RE; PLN22-228
Response to 'Request for Additional Information'

This letter is an itemized response to your 'Request for Additional Information' dated 1-13-23 for PLN22-228.

Project Address: 14500 ARNERICH ROAD APN: 53712012
City: LOS GATOS, CA Zip: 95030

VIEWSHED ANALYSIS SECTION - A - LOOKING WEST

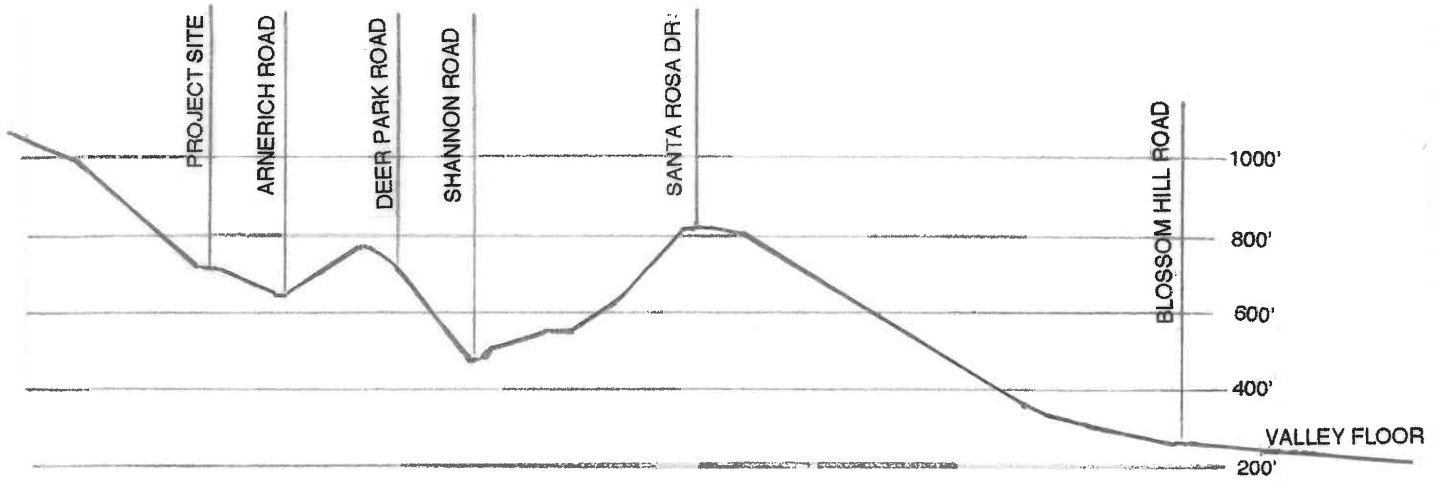
7. As the subject parcel has a -d1 overlay, it is subject to design review. **Please provide a viewshed analysis showing how the proposed development will be viewed, as seen from various angles of the valley floor** so staff can further evaluate the potential visibility of the new development proposed on the subject parcel.

- 6 See revised Estimated Grading Quantities on sheets 1 & 3.
- 7 See the attached Viewshed Analysis. The subject parcel is not visible from the valley floor due to intervening hillsides and vegetation.

SUBJECT PARCEL NOT VISIBLE FROM VALLEY FLOOR DUE TO INTERVENING HILLSIDES
